IN THE UNITED STATES DISTRICT COURT
FOR THE WESTERN DISTRICT OF MICHIGAN
SOUTHERN DIVISION

THIRD MODIFICATION OF CONSENT DECREE

WHEREAS, Paragraph 68 of the Consent Decree includes provisions pertaining to the installation and spacing of Screw Anchor supports along portions of Line 5 (referred to in the Consent Decree as the “Dual Pipelines”) located within the Straits of Mackinac.

Line 5 SOM - East Span Profile and Anchor Locations

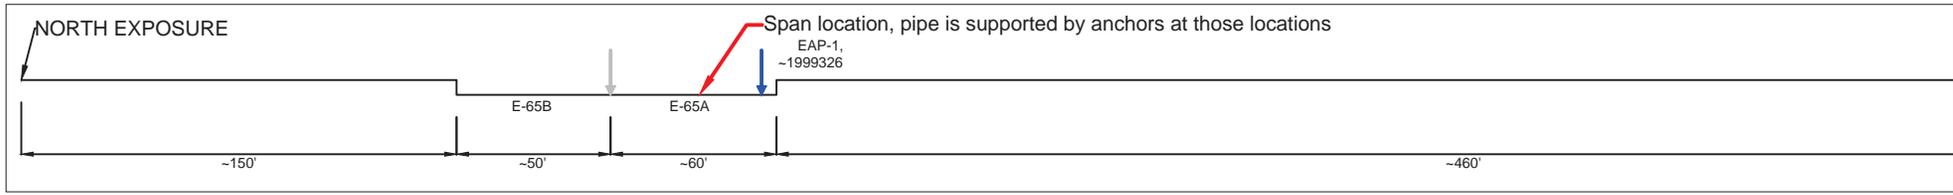
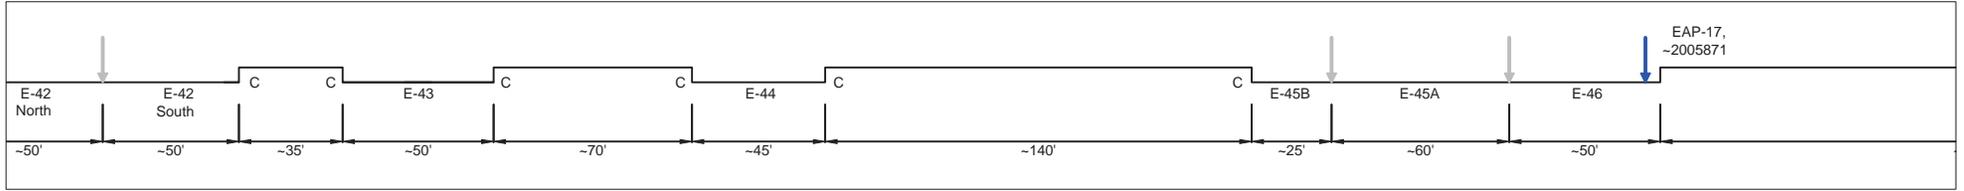
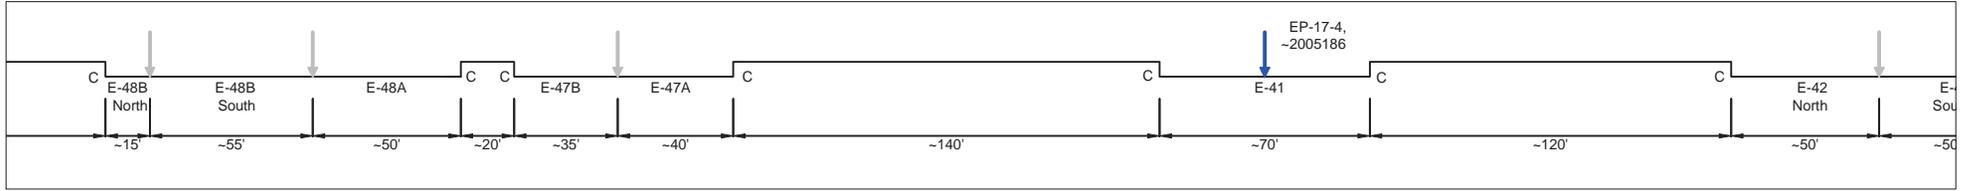
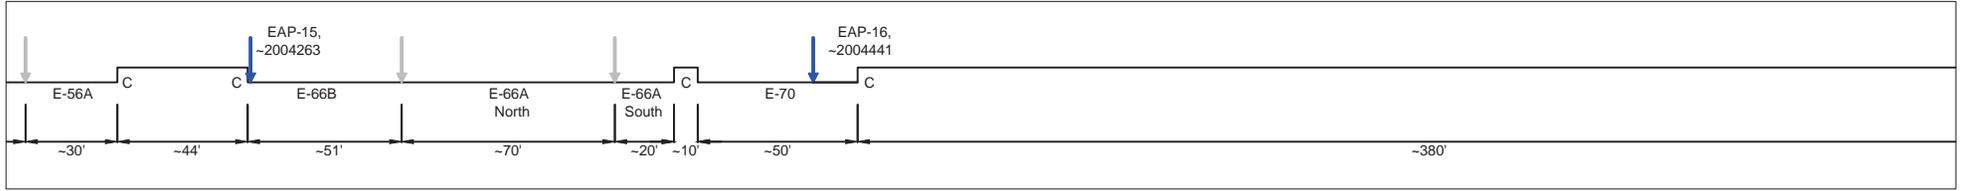
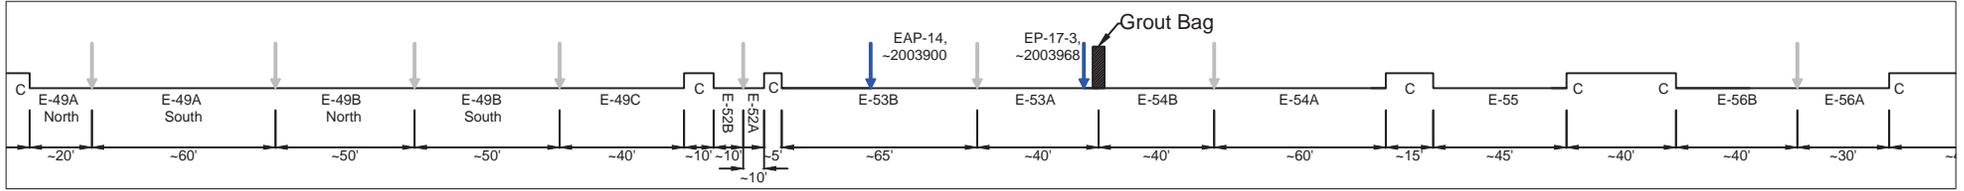
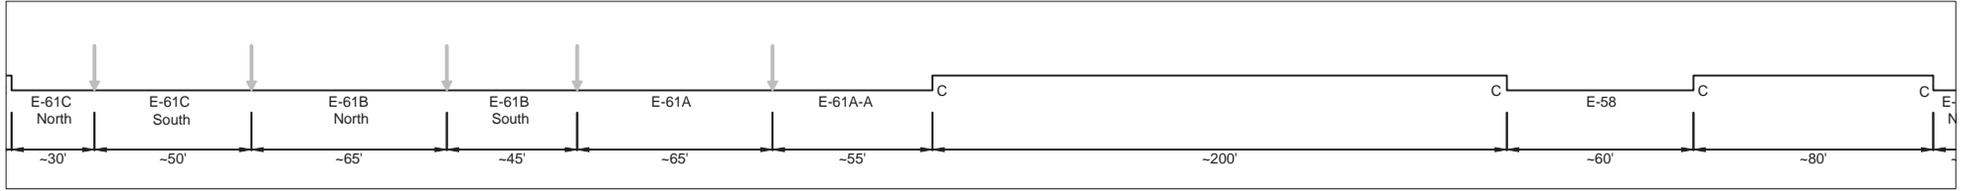
(1) By October 1, 2018, Enbridge shall install Screw Anchors at the locations identified in Table 1 of Attachment A. A graphic representation showing the approximate locations of these Screw Anchors in relation to existing Screw Anchor locations and previously observed span locations is provided in Table 2. As necessary to facilitate installation of Screw Anchors in light of conditions at particular locations identified in Table 1 of Attachment A, Enbridge may adjust the location of any Screw Anchor by up to five feet in either direction.
